Complete App Email for R13-3708

WVDEP Questions and MGS Response
MGS CNP 1, LLC/BECCS Plant
Permit Application No. R13-3708
Plant ID No. 053-00134

MGS CNP 1, LLC; BECCS Plant
Facility ID No. 053-00134
Application No. R13-3708

DAQ list of Issues/Concern/Questions regarding Permit Application 13-3708 for MGS CNP1/BECCS Plant.

**Visio-SO2_CO2_scrubbers_W_Compression_Dehy_units.pdf**
39K

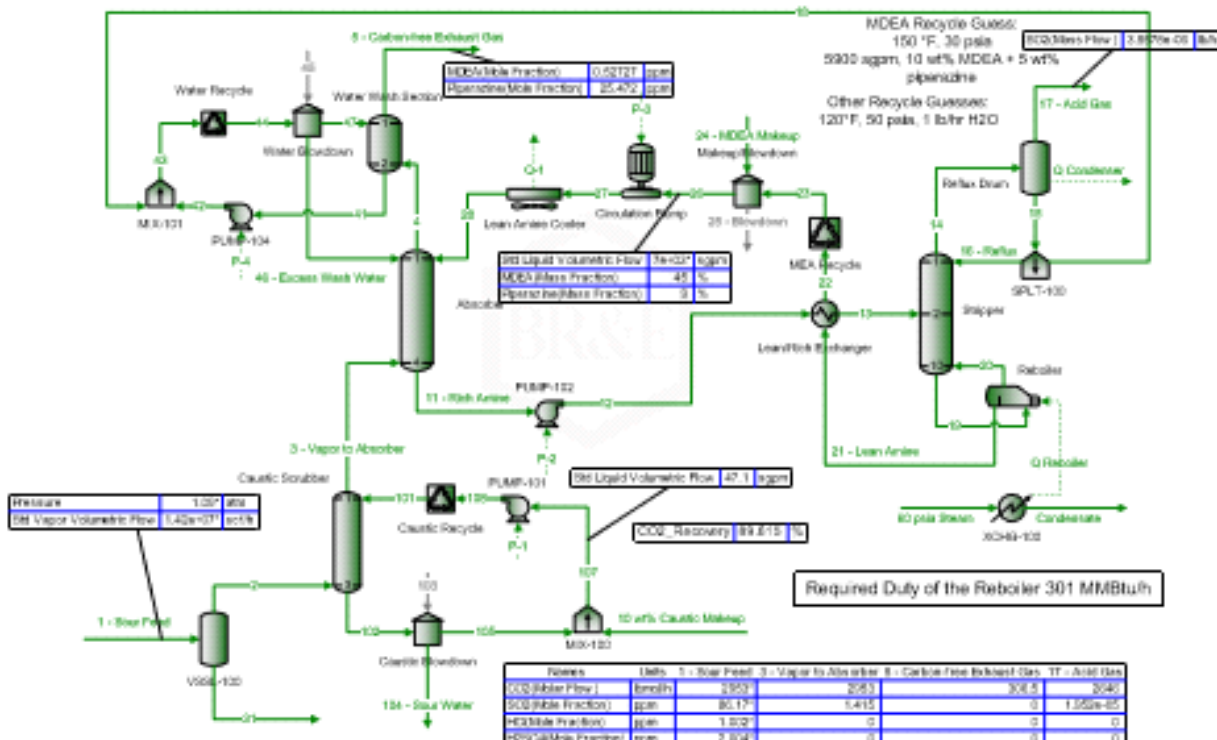
Here is the pdf of the caustic and amine scrubbers. I am still having issues getting a pipeline block to converge in a compression flow sheet.

Using either solely MDEA or a mixture of MDEA plus piperazine, any and all of the residual SO2 exiting the caustic scrubber will be absorbed in the rich amine or lockup in the amine. The real question is does the CO2 dehydrator release any of this captured SO2.

I would assume it does. I found that if the caustic scrubber is ran a little harder the amine unit converges completely. Once I get the "compression and injection" and "dehydration" flow sheet intergraded completely, I will share the Promax file with you.
